Subject: Zion Station Units 1 and 2
Application for Emergency Technical Specification
Amendment to Facility Operating License
DPR-39 and DPR-48
NRC Docket Nos. 50-295 and 50-304

EMERGENCY LICENSE AMENDMENT REQUEST 94-05

TYPE C LEAK RATE TESTING

FIGURE 1

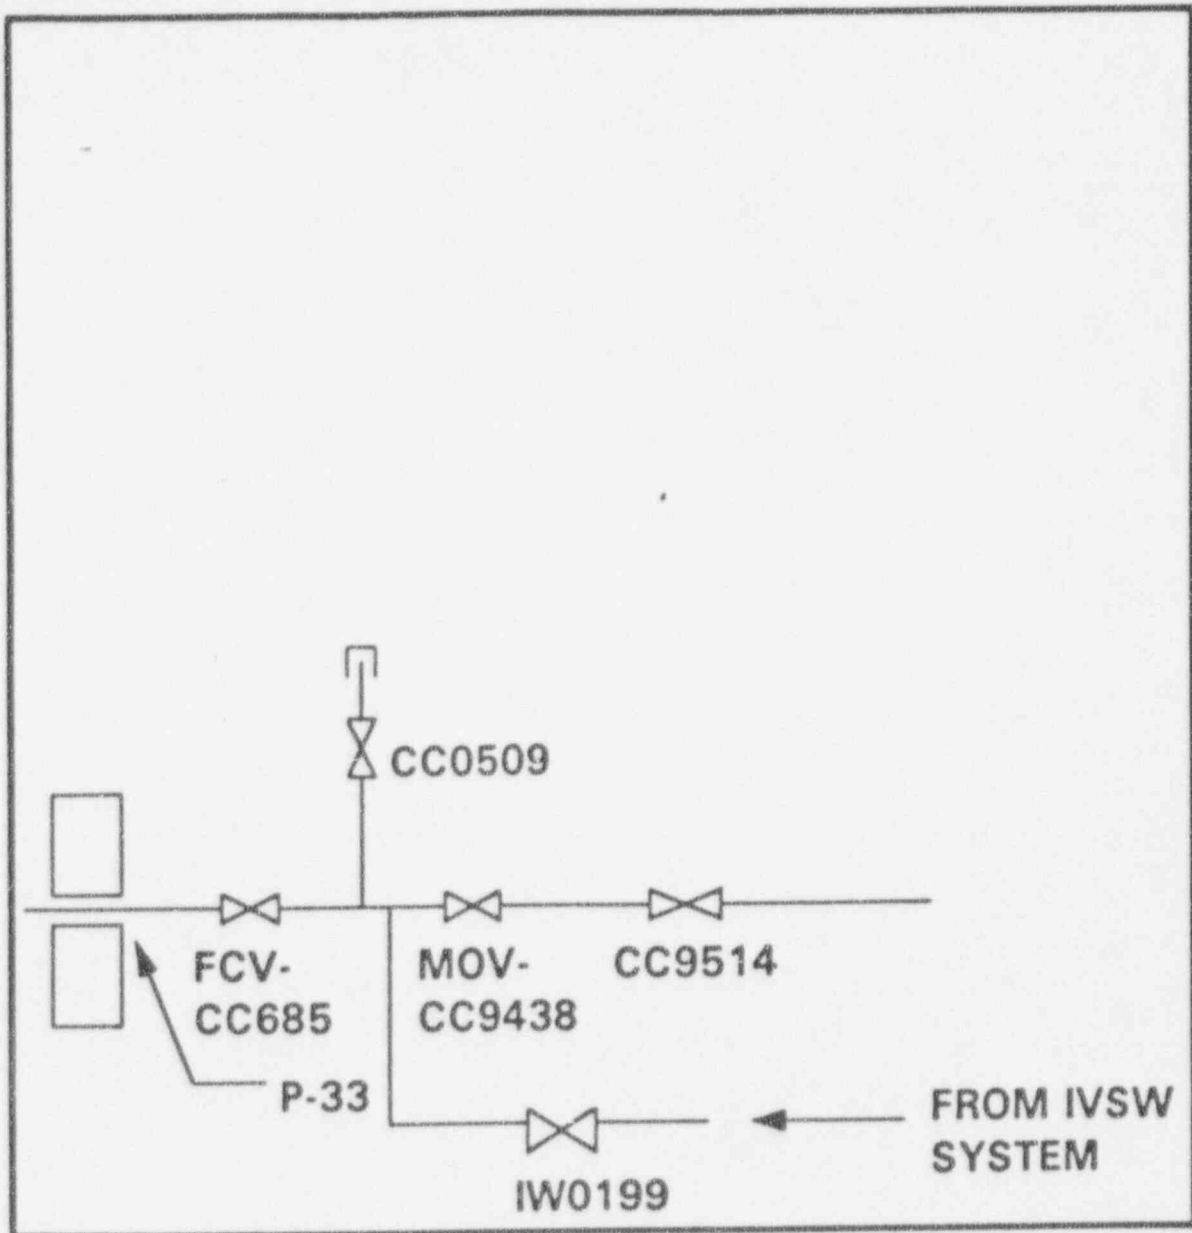
Valves 1(2)MOV-CC685 are wedge type gate valves which are not provided with automatic isolation valve seal water injection. Manual isolation valve seal water injection is provided for the piping between 1(2)MOV-CC685 and 1(2)MOV-CC9438. Refer to attached Figure 1. Because the component cooling water return line from the reactor coolant pump thermal barriers is a line that is used intermittently under post accident conditions, the associated containment isolation valves 1(2)MOV-CC685 and 1(2)MOV-CC9438 are required to be Type C tested in accordance with 10CFR50 Appendix J.

- 4) Manually initiated Isolation Valve Seal Water (IVSW) is provided to the component cooling water return line between valves 1(2)MOV-CC685 and 1(2)MOV-CC9438. Manual seal water injection is provided for lines which remain in service for a time, or are used periodically, subsequent to an accident. Manual initiation of seal water is initiated during long term recovery from an accident. Guidance is provided in the Emergency Operating Procedures to initiate seal water to the valves. Emergency Procedure E-1, 'Loss of Reactor or Secondary Coolant', Step 20 directs the Technical Support Center to evaluate the need for operation of manual

- 1) Prior to entering Mode 5 for refueling outage Z1R14, the Type C leak rate testing requirements of this specification are not applicable to Unit 1 valve 1MOV-CC685.
- 2) Prior to entering Mode 5 for refueling outage Z2R13, the Type C leak rate testing requirements of this specification are not applicable to Unit 2 valve 2MOV-CC685.
